South Texas Project Electric Generating Station P.O. Box 289 Wadsworth, Texas 77483

January 6, 2010
U7-C-STP-NRC-110006

South Texas Project
Units 3 and 4
Docket Nos. 52-012 and 52-013
Response to Request for Additional Information

RAI 04.04-4

Figure 6C-1 Schematic of Cassette Type Suction Strainer

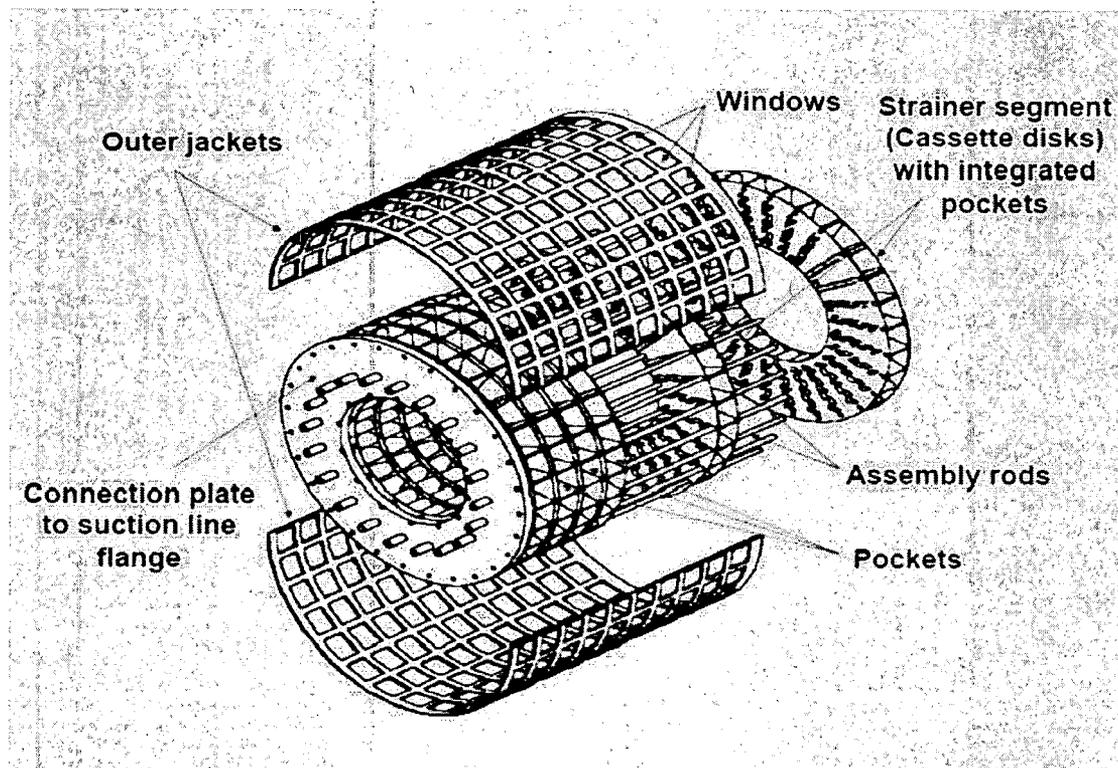
STD DEP 6C-1 (Figure 6C-1, ~~6C-2, 6C-3, 6C-4, and 6C-5~~)

Figure 6C-2 Core Inlet Delta P for Blocked and Unblocked Cases

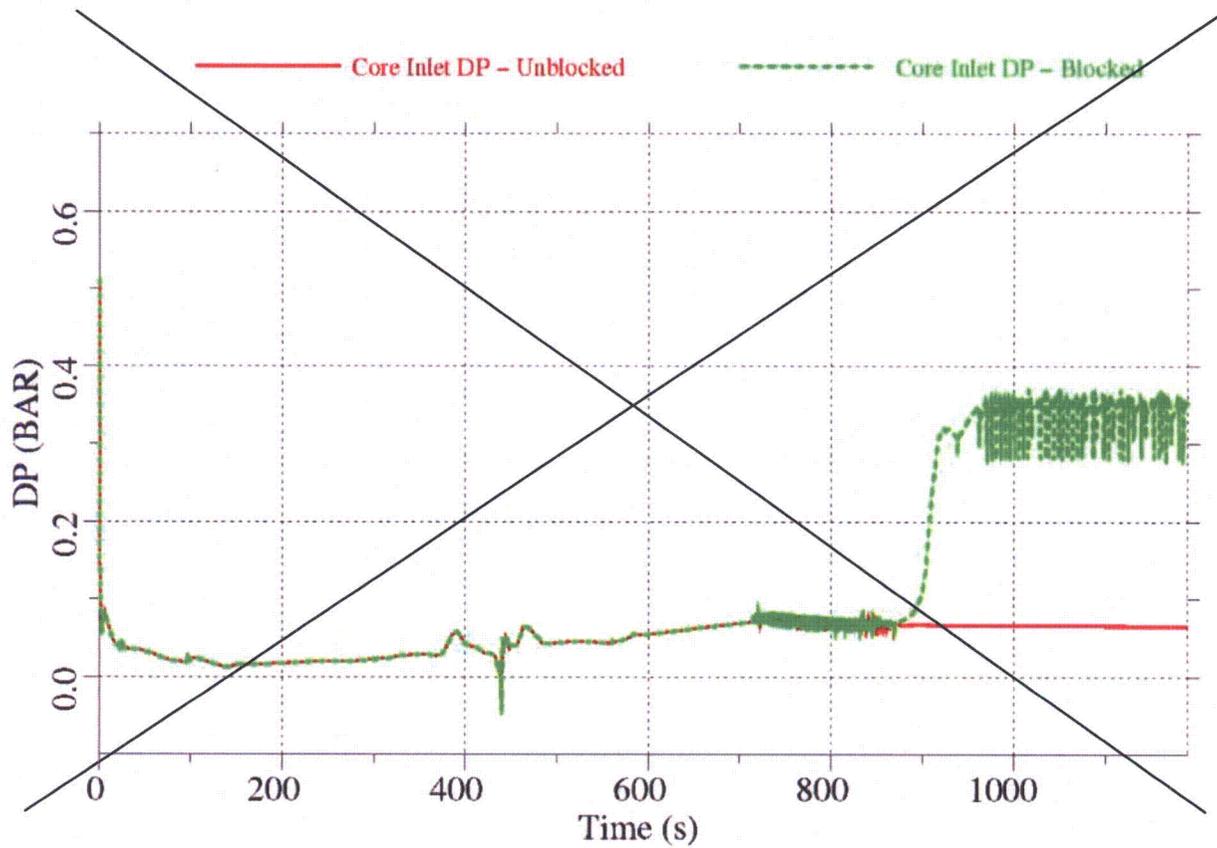
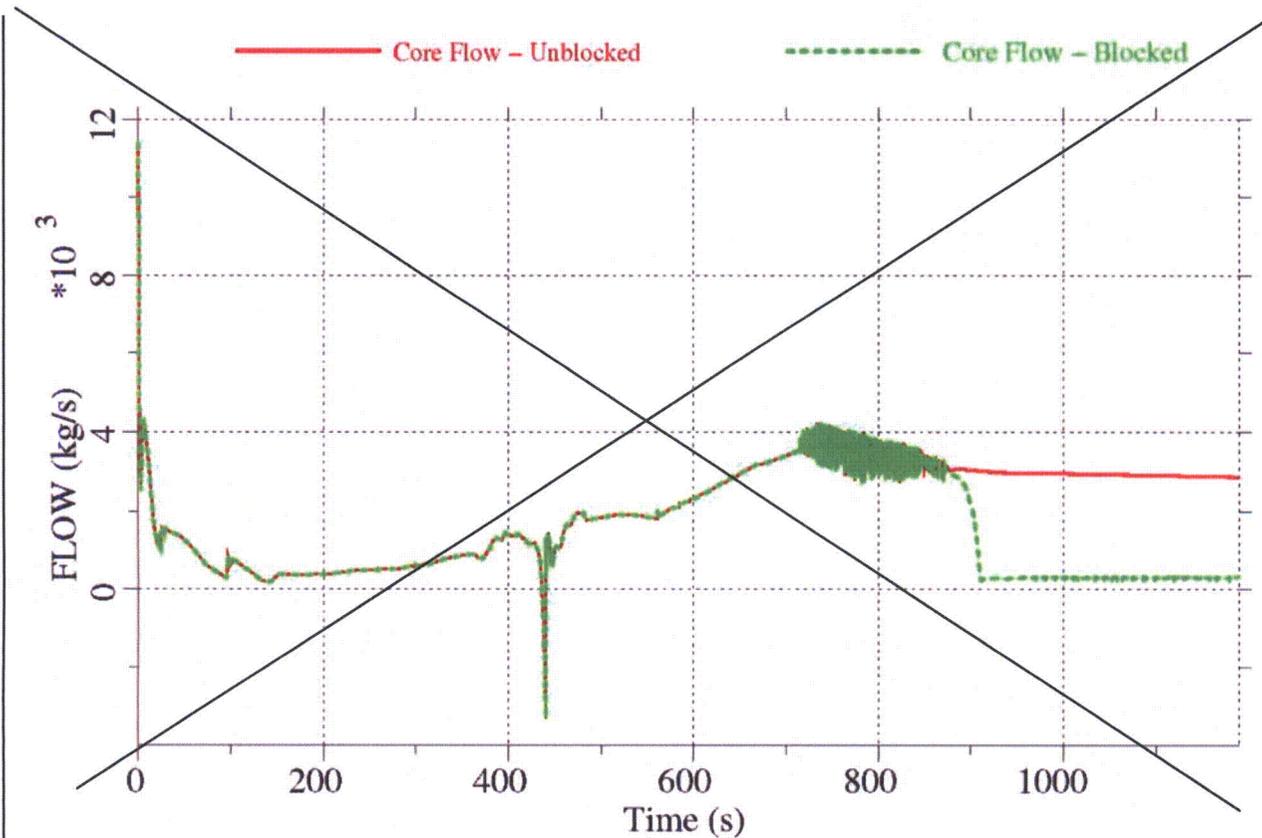
During the NRC staff audit (held on July 12, 2010) of the calculations supporting the downstream fuel effects test acceptance criterion of 5.076 psid (U7-C-STP-NRC-100044 dated February 22, 2010), the staff discovered that the calculations were based on Optima II fuel rather than the GE-7 fuel approved in the ABWR DCD. Explain how the proposed criterion is suitable for the fuel design that is currently the basis for the ABWR design.

Figures 6C-2, 6C-3, and 6C-4 An analysis was performed to compare the core inlet DP, flow rate and void fractions for the cases with no blockage and with blockage resulting in a reduction of flow area by 90% of inlet flow area an increase of the hydraulic resistance of the fuel inlet. Five minutes is the estimated amount of time required for debris in the containment to start to reach the fuel filters. The models assume clogging begins at 850 seconds because that is when the flow through the core reaches steady state. In order to ensure any effects seen are covered by the changes being made, steady state flow is required. The analysis results demonstrate that, despite a very high level of blockage hydraulic resistance, sufficient flow remains available to the core to ensure that the core void fraction both in the hot assembly and average assembly remain < 0.95 .
